**AMENDMENTS TO THE DRAWINGS**

### **REMARKS**

**FIG. 1**

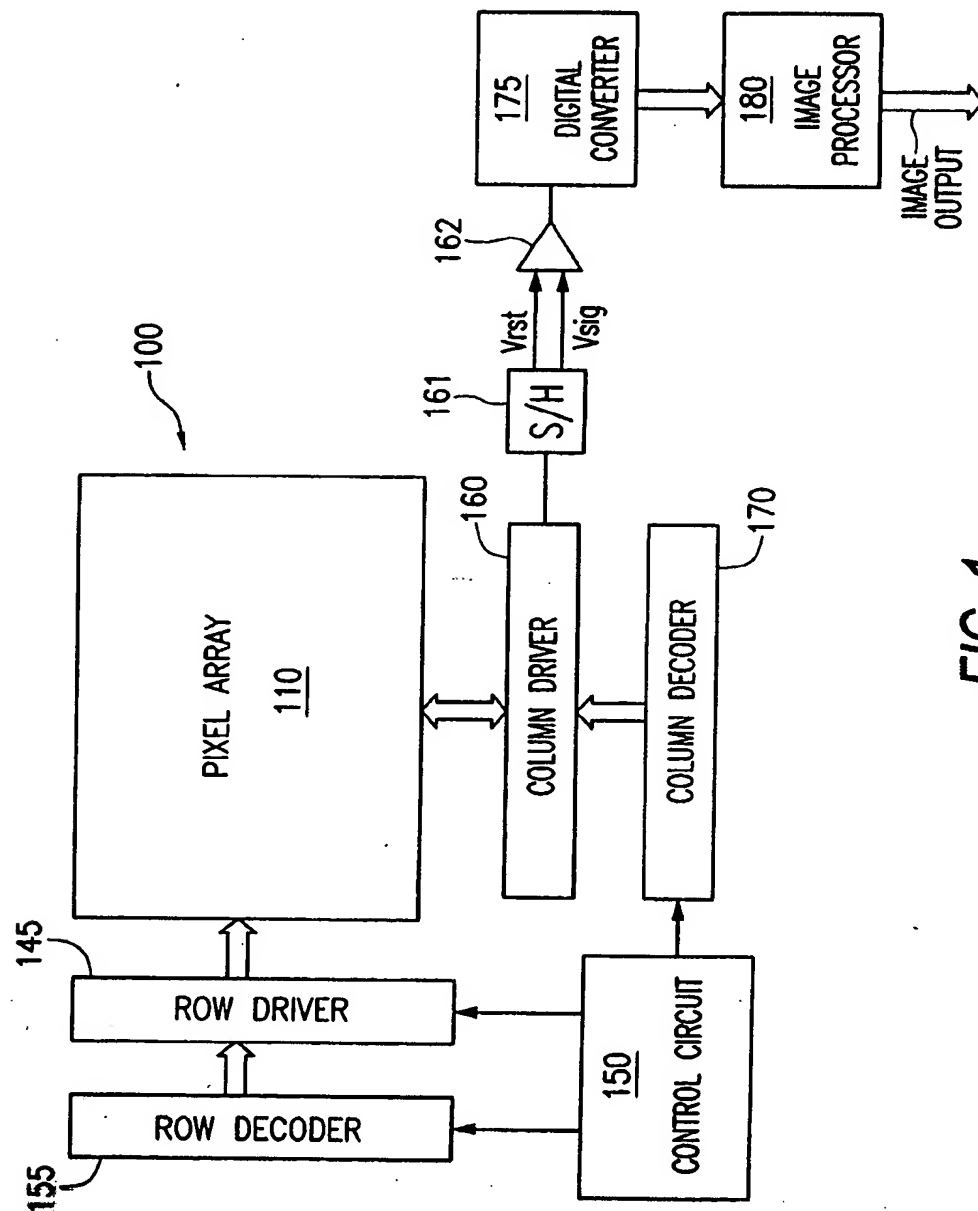
Figures 1 and 2 stand objected to as failing to comply with 37 CFR 1.84(p)(4) and (5). Figures 1 and 2 have been revised to indicate that they are prior art and Figure 2 has been revised to re-label the row select transistor with reference character "36." Applicant submits that the figures are in compliance with 37 CFR 1.84. In light of this revision, Applicant respectfully requests that the objection to the figures be withdrawn.

(PRIOR ART)
